# TROLLEYBUS DEVELOPMENT

## 1828-1840 NASH ROAD AND 3090-3158 HANCOCK ROAD

TIS ADDENDUM AND  
RESPONSE TO COMMENTS

PROJECT NO.: 17M-02249-00  
DATE: JUNE 27, 2019

**Figure 1 - 1828-1840 Nash Road and 3090-3158 Hancock Road Updated Site Plan**

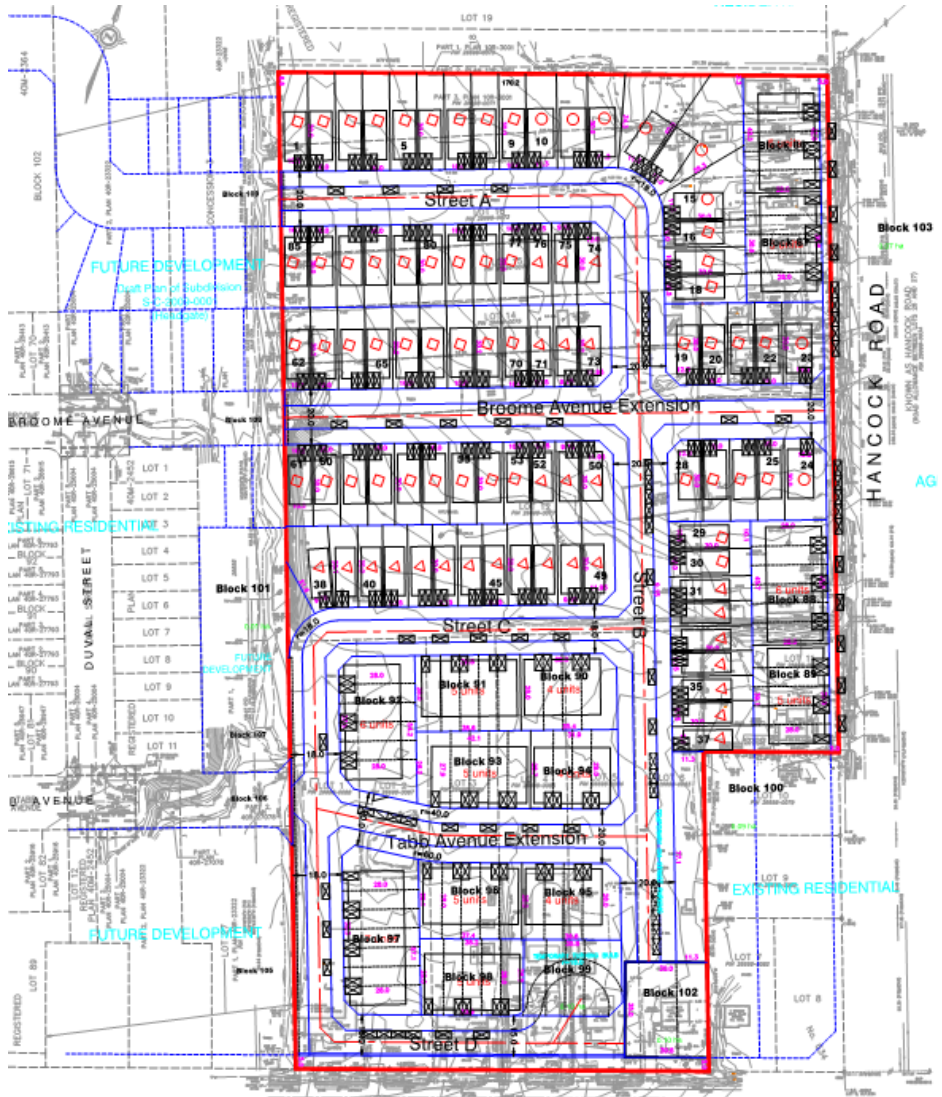
- 1 **Comment 2.12.** *The Transportation Impact Study must be revised to be compatible with the (future) revised draft plan.*

**Response:** Noted, this TIS Addendum and Response Letter addresses this comment. As noted in Table 1, the overall unit count is very similar between the current submission and the April 2018 submission. The auto trip generation for the current site plan, which is based on the same methodology as the April 2018 TIS, is presented in Table 2.

# ON-STREET PARKING PLAN

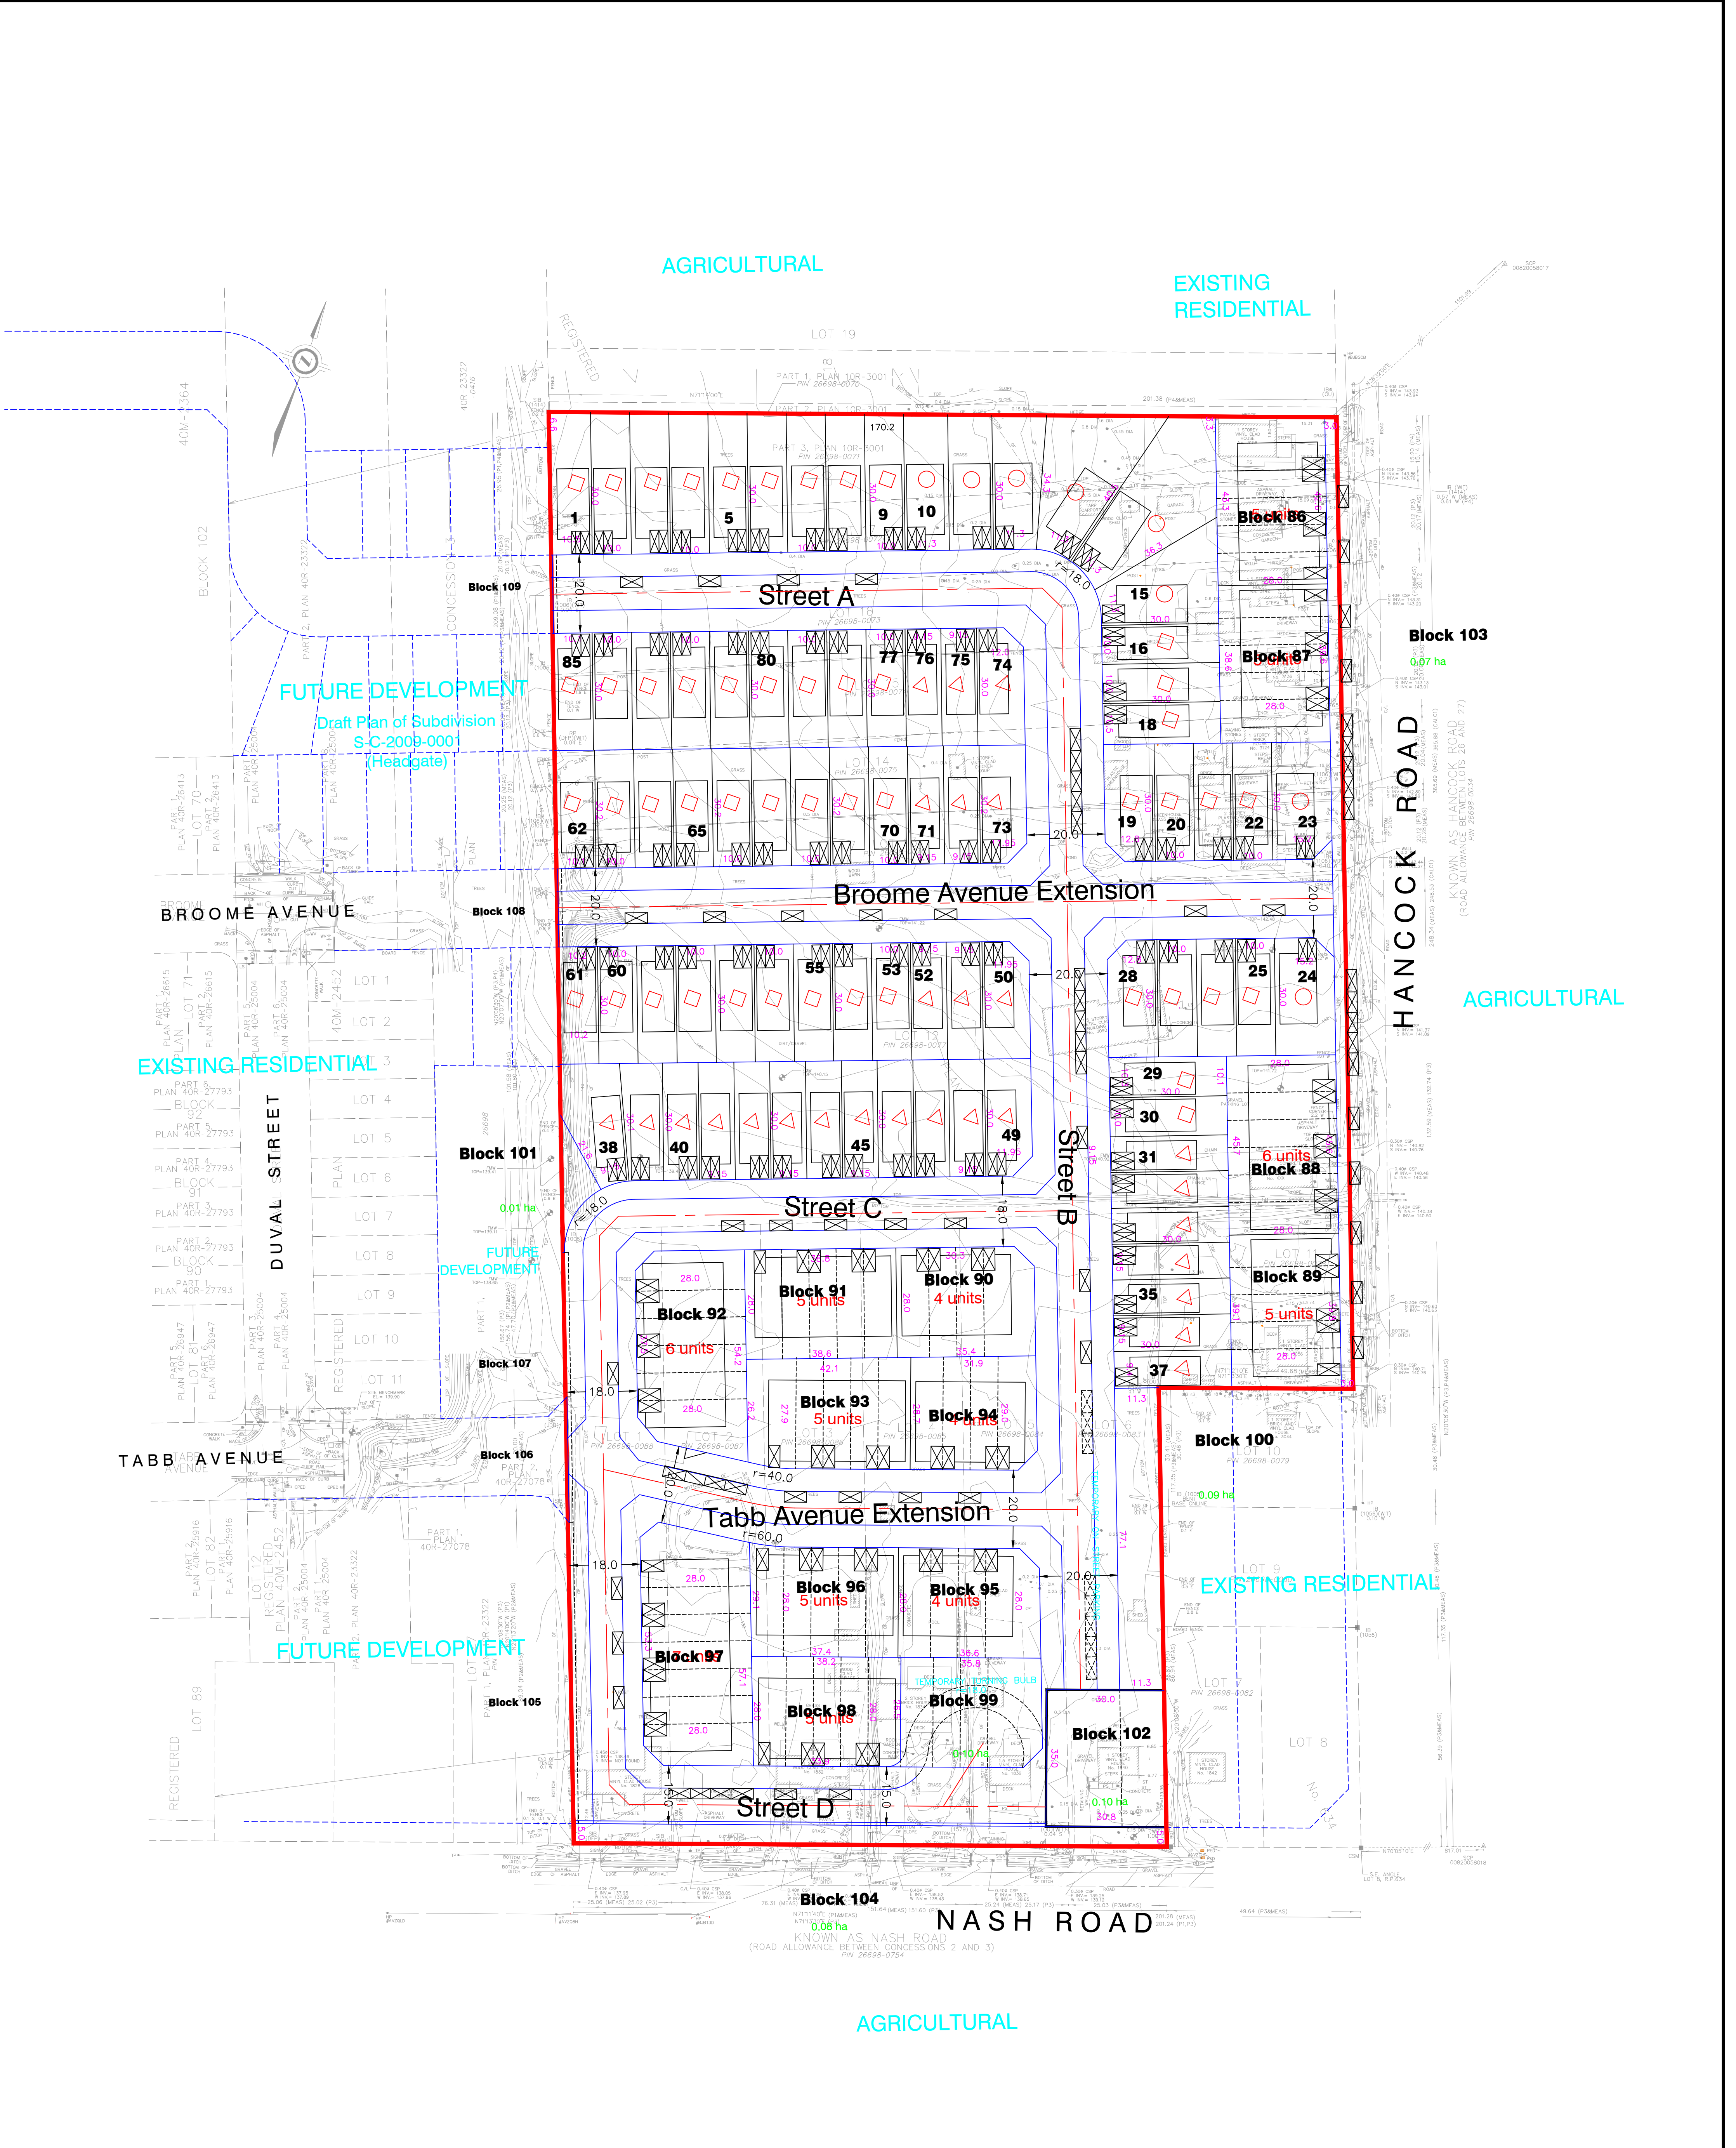
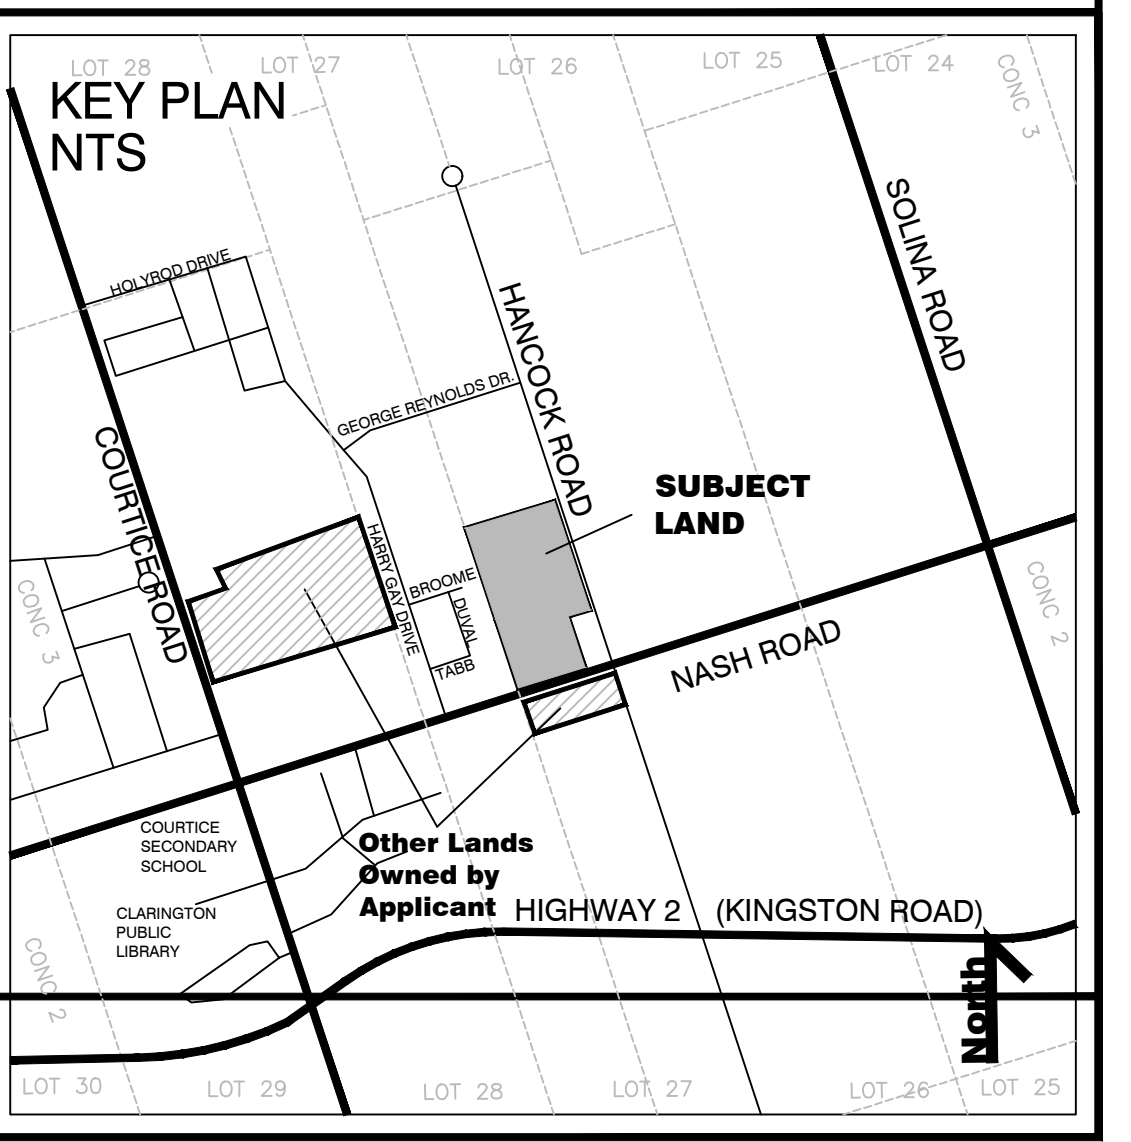
- 2 **Comment 2.13.** *The On-Street Parking Plan is not satisfactory as submitted. The Plan must be revised to illustrate driveways and on-street vehicles with a length of 5.5 metres. All vehicles/parking locations that are depicted on the Plan must be in conformity with current municipal parking regulations.*

- 4 Comment 2.21.** *The applicant must submit a plan drawing indicating the proposed entrance and driveway location for all corner lots. The proposed entrances must conform to all current zoning requirements. Any future dwellings constructed on corner lots within the subject draft plan must have entrances, driveways and garages that are compatible with the required plan. Kinked driveways will not be permitted. The final plan is subject to the approval of the Director of Engineering Services prior to the approval of this draft plan.*

**Response:** Noted, an On-street Parking Plan has been updated with parking spaces with lengths of 5.5 m as shown in **Figure 2**. The parking spaces are adequate in that they do not block the individual driveways, and are setback adequately from the intersections.

**Response:** This is acknowledged and the driveway locations and entrances are shown in the parking plan in Figure 2. The figure shows that virtually all of the driveways/parking entrances for the corner lots front onto tangential sections of the road. The only exception are the the two units (13 & 14) that are at the elbow of the road. However, there are no on-street parking proposed in these vicinities which will allow for adequate inbound and outbound movements.

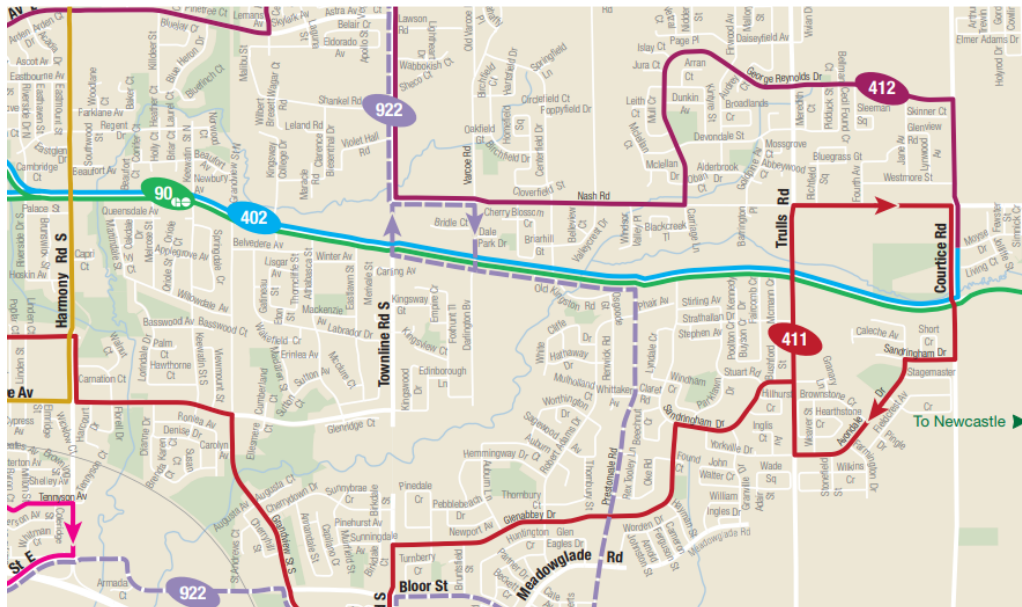
- 9 **Comment 1.3.** *In Section 2.2 (p. 3) of the TIS, the opening paragraph notes the services are "within the vicinity of the site", however, the site is not shown on the screen shot of the map insert shown. As our analysis shows that the site is outside the 400 metres to transit access, the Study's reference to "vicinity" is not accurate.*

**Response:** The 2019 Durham Region Transit route map is shown below. The system map does not extend east of what is shown (i.e., the subject site is outside the view to the east). The distance between the subject site and the nearest bus stops at Courtice Road and Nash Road ranges from 650m to 1km.
